Technical Note TN-774  
**Upgrading the Tait Orca Vehicle  
Kit to support “Green”  
Chassis Tait Orca Radios**

21 May 2003

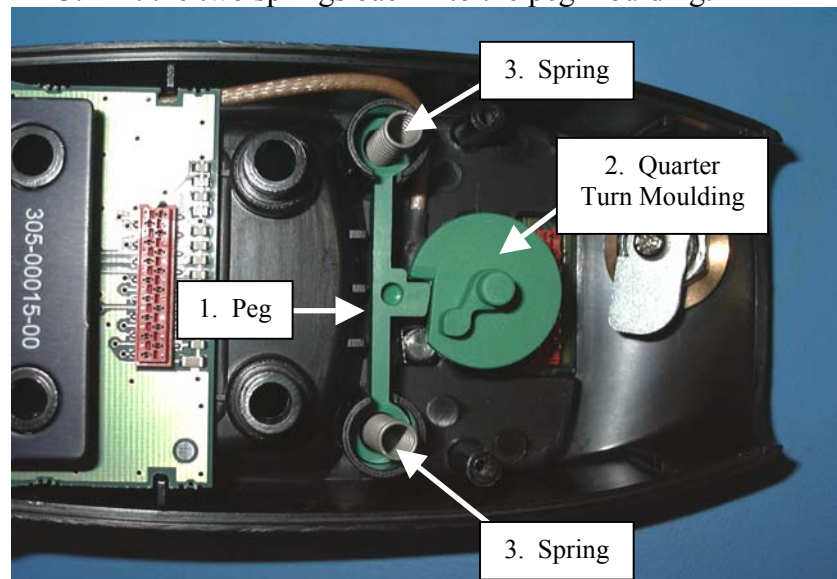
- 8) Remove the two springs, the peg moulding and quarter turn moulding.

- 9) Fit the new parts in the follow order:
1. Fit the new peg moulding into the front panel.
  2. Insert the quarter turn moulding and rotate it until the peg moulding prevents it from turning (as shown below).
  3. Fit the two springs back into the peg moulding.
